NOTICE OF PUBLIC HEARING

NORTHEASTERN NEVADA REGIONAL HOSPITAL, 2001 ERRECART BLVD., ELKO, NV 89801, IS REQUESTING A VARIANCE, #796, FROM THE NEVADA STATE BOARD OF HEALTH REGULATIONS.

RE: Variance Request # 796 Regarding Imaging Room Space Requirements for Northeastern Nevada Regional Hospital

NORTHEASTERN NEVADA REGIONAL HOSPITAL – MRI EQUIP REPLACEMENT | NARRATIVE

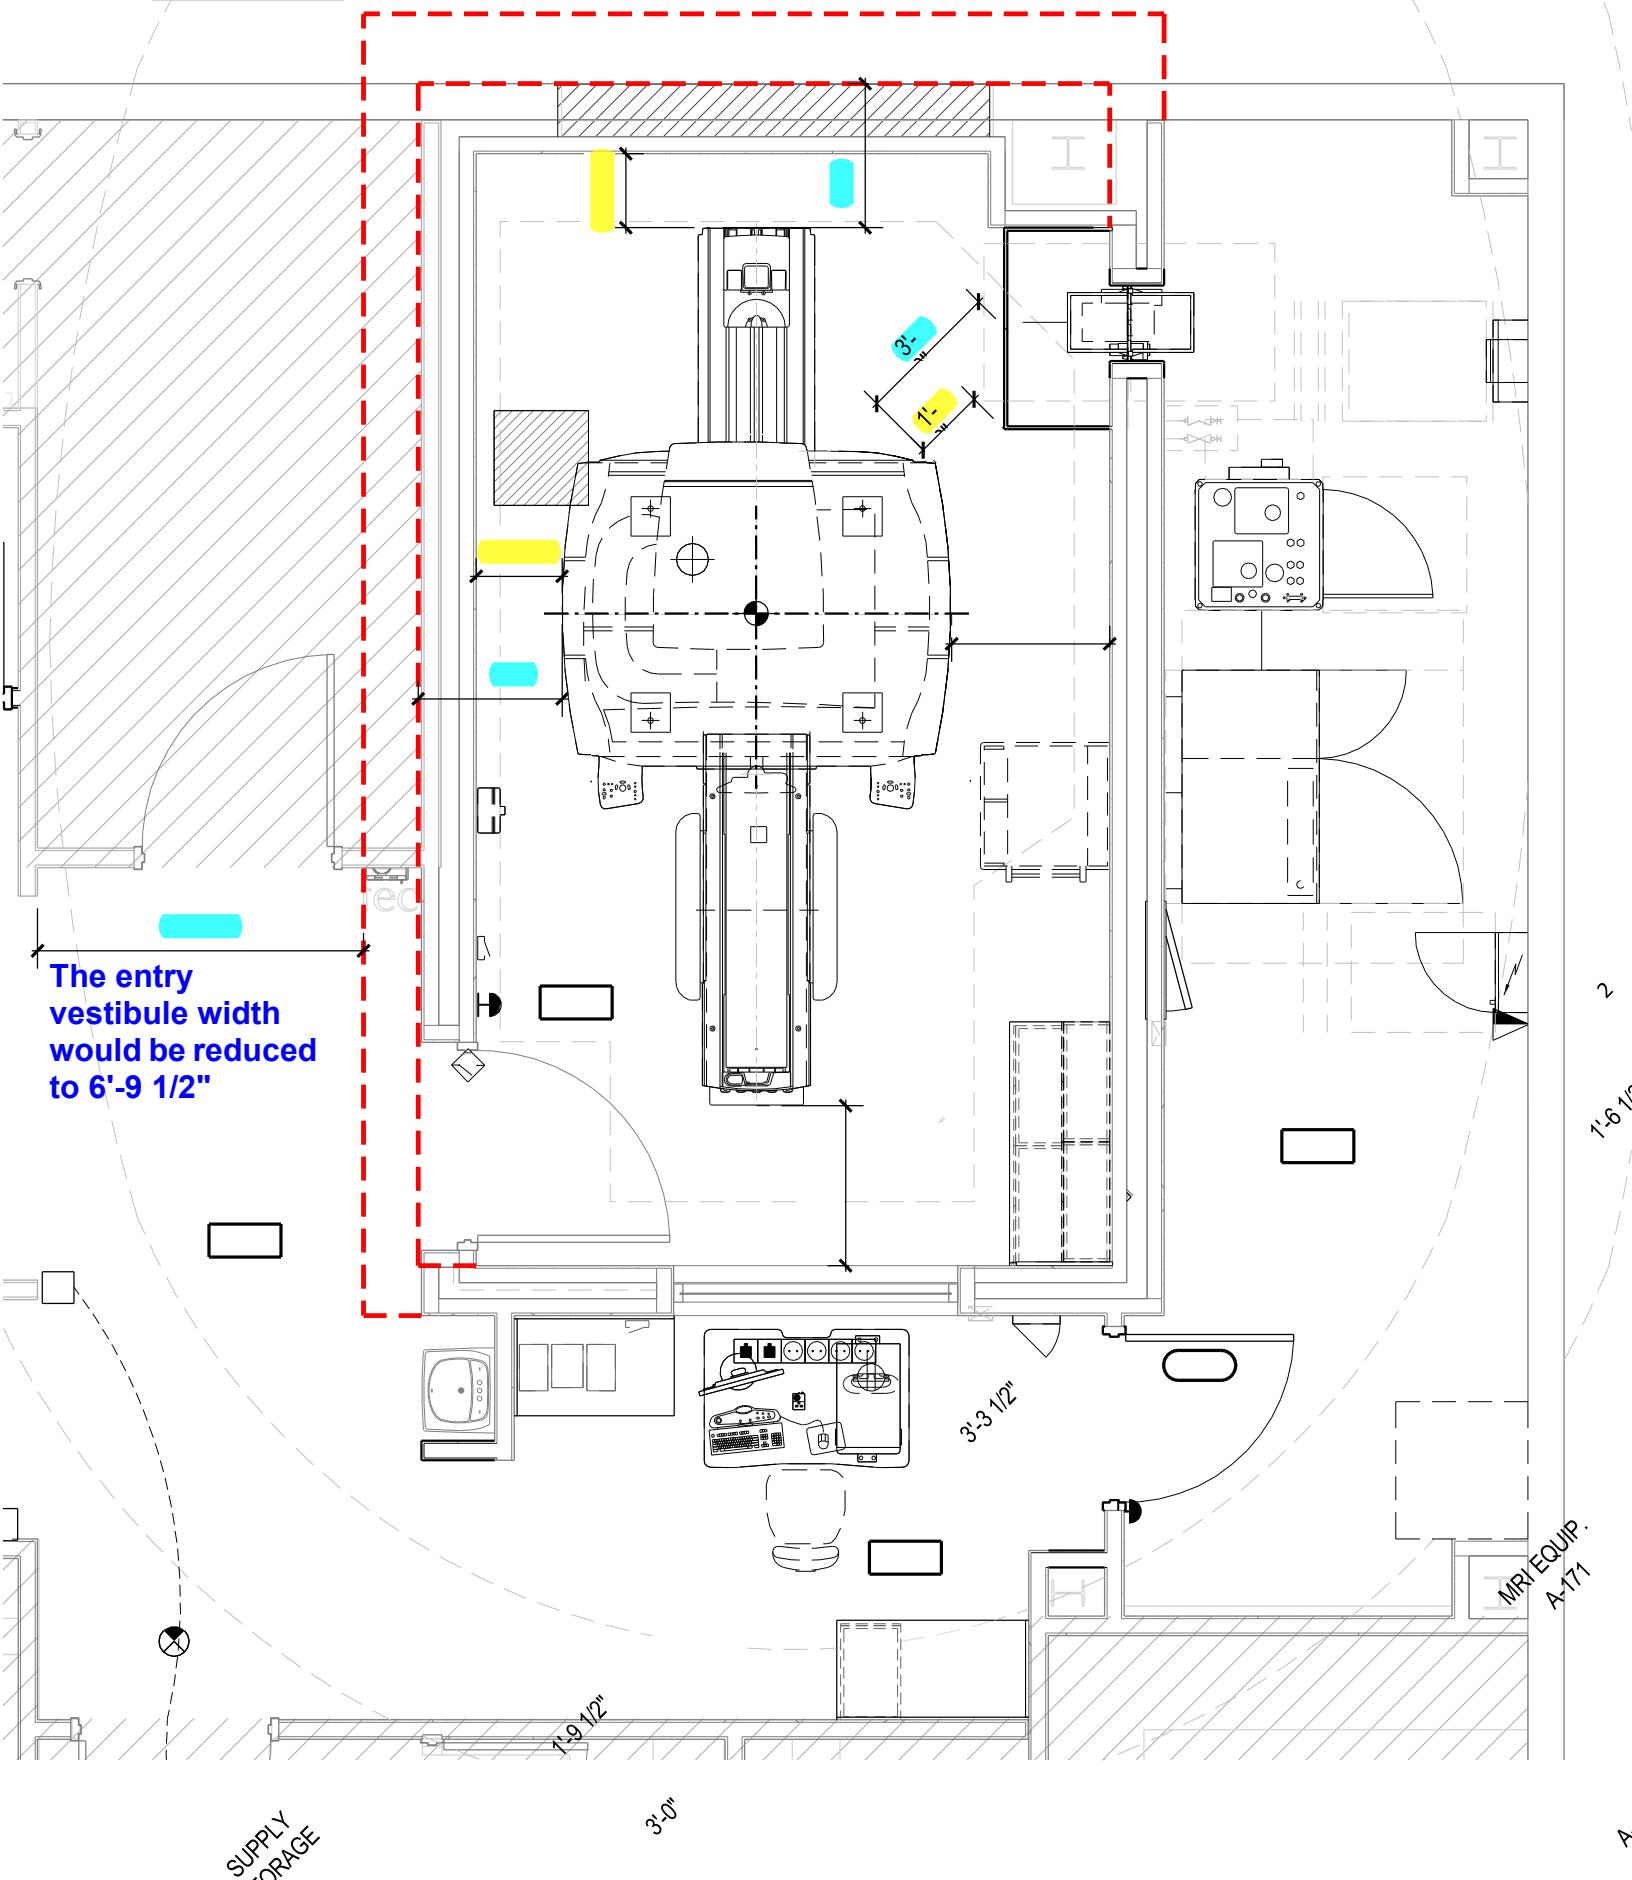
The Applicant requests a variance from the requirement to provide three (3) feet of clearance on all sides of the freestanding MRI device, including the patient table, gantry, or assembly. Due to the existing condition of the building, the MRI room does not contain sufficient square footage to provide the three (3) feet clearance, around the new MRI equipment.

The financial hardship described by the Applicant is specific to existing conditions of the building. The north exterior wall would need to be moved one (1) foot and four (4) inches to the north and the sidewall would need to move one (1) foot and two and a half (2.5) inches to the west. This change would require modification of the existing R&F enclosure to accommodate the new layout. In addition, a structural engineer would need to be engaged to provide details for the extended slab and roofing systems. Additional modifications to the electrical and mechanical building systems would also be required.

To maintain the required 3'-0" clearances on all sides for the existing MRI room, we would need to make major modifications to the existing space. The north exterior wall would need to move plan north 1'-4" and the sidewall would need to move plan west 1'-2 1/2". This change would include modifying the existing R&F enclosure to accommodate the new layout. In addition, a structural engineer would need to be engaged to provide details for the extended slab and roofing systems. Also include additional modifications to electrical and mechanical building systems.

This change would reduce the Entry Vestibule to the MRI room to 6'-9 1/2" wide.

Dashed red line represents modifications to interior and exterior walls.

Based upon the foregoing Findings of Fact and Conclusions of Law, and good cause appearing, therefore, IT IS HEREBY ORDERED, ADJUDGED, AND DECREED that the variance to NAC 449.3154(2) is APPROVED as presented; specifically, the hospital will be allowed to have clearances around MRI equipment less than the required 3 feet.
